Contemplating the 1850 BUG and fiddling with imaginary laser-toolpaths I realised a flaw in the mindset discussing inside/outside toolpaths.

FS#1850 - Toolpath error  
User who did this - Andrew (andrew)

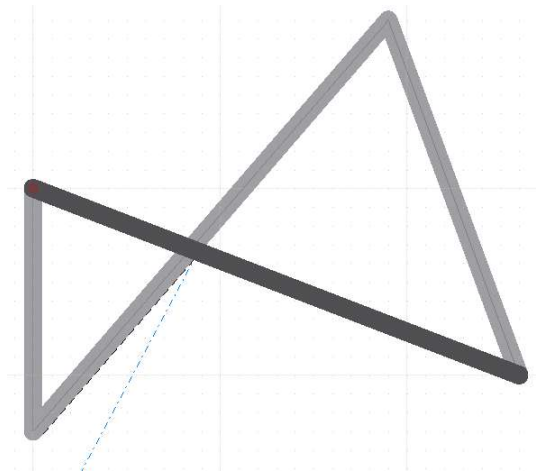
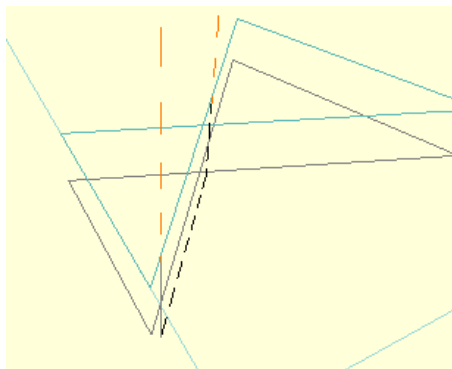
Slot milling, as pocket milling, is **left** or / and **right** milling. Inside or outside are merely accidental humanlike definitions. As in the figure to the right defined by four coordinates, is there an inside and outside?

This flaw in mindset is very remarkable in the difference whenever selecting the On, Inside or Outside toolpath.

A nightmare if one tries to engrave these four lines at an offset distance.
